Sunset Arts & Advertising Subcommittee Briefing Memo Current and Historic Preservation Planning

8760 Sunset Boulevard

Proposed Billboard Application: The purpose of this meeting is to give initial feedback on design aspects of the second design proposal for a billboard structure at this location. This includes a two sided, full-motion animated billboard. This site currently has no billboards.

Previously Proposed Billboard Design, October 10, 2024

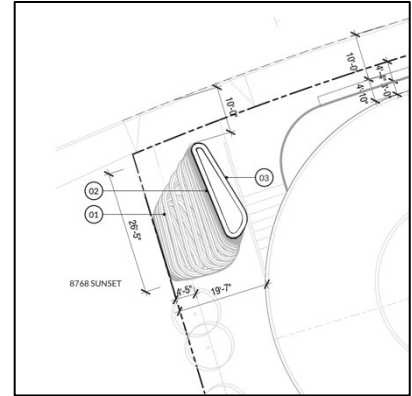
1. Design of Billboard:

- a. Consider glare impacts and anti-reflective coating.
- b. Preferred a design with more distinctive rings, less solid, more open. Maximize the cuts – to imply the overlap of concentric rings and make it more 3D. An open to make it less enclosed. More open, less restricted.

- c. Unbroken surfaces or panels of billboard need more openness or perforation.
- d. Design is unfinished and needs more detail.
- e. Cylindrical structure on a post does not complement the building. Consider other shapes or sizes.

- f. Design falls a little flat compared to the amazing building. Maybe on right path but needs more creativity, expression, etc.
- g. Don't want billboard design to take away from the unique building.

- h. Preferred dynamism and expression of the original concept award.
- i. For cylinder use a matte, non-reflective material.
- j. Can the surface treatment be like a film (like the back of Apple[™])- so that distributes light and avoids glare?

- k. Opportunity to move it towards iconic nature of building – make it more architectural.
- l. Questions regarding vertical structure at the sidewalk.

- m. There is an opportunity for color of the building to be in the billboard. Play off it. Green may not be a good idea - the building may not always be green.

- n. Perhaps make it more architectural and unique and less minimalist.
- o. “Coke” can shape approach is not preferred.

The applicant team incorporated some of these comments but also felt that a more involved re-design would provide an even better approach and would more effectively address the concerns from the subcommittee. Therefore, the applicant team is now presenting a new approach with a completely different design for the billboard and is now requesting two full motion sign faces. The site improvements remain the same as previously reviewed.

The new proposed design addresses the concerns about shape. It takes inspiration from the concept of “contrapposto” which comes from the Italian renaissance art movement. Contrapposto, or counter pose, literally describes a human figure positioned with most of its weight on one foot while its torso, shoulders, and arms twist off-axis. This inspiration also harkens back to the original forum-like building itself, “The Beauty & Youth Pavilion”. In the shape of the billboard, the design represents a “dynamic imbalance” within the form. (See page 20 of the project plans.)

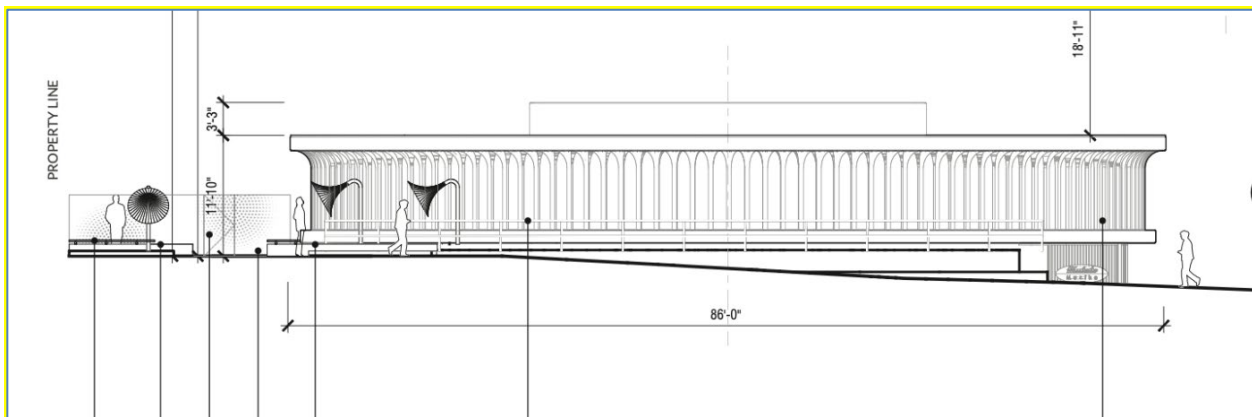
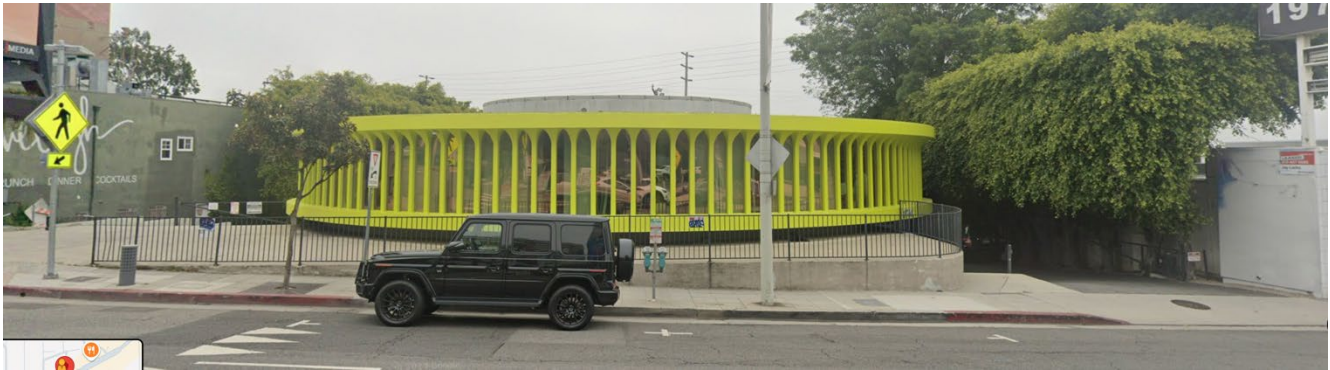
The plaza itself will contain bench seating and be finished with gray, 4" thick narrow modular pavers. The benches should be carefully designed to promote the types of activity desired. Contrasting the concrete sidewalk, the pavers will help distinguish the private plaza from the sidewalk. Alternating colors or paving or the introduction of creative patterns would further help mark the plaza as a unique place. Lighting of the plaza should be soft and subdued but account for nighttime safety considerations.
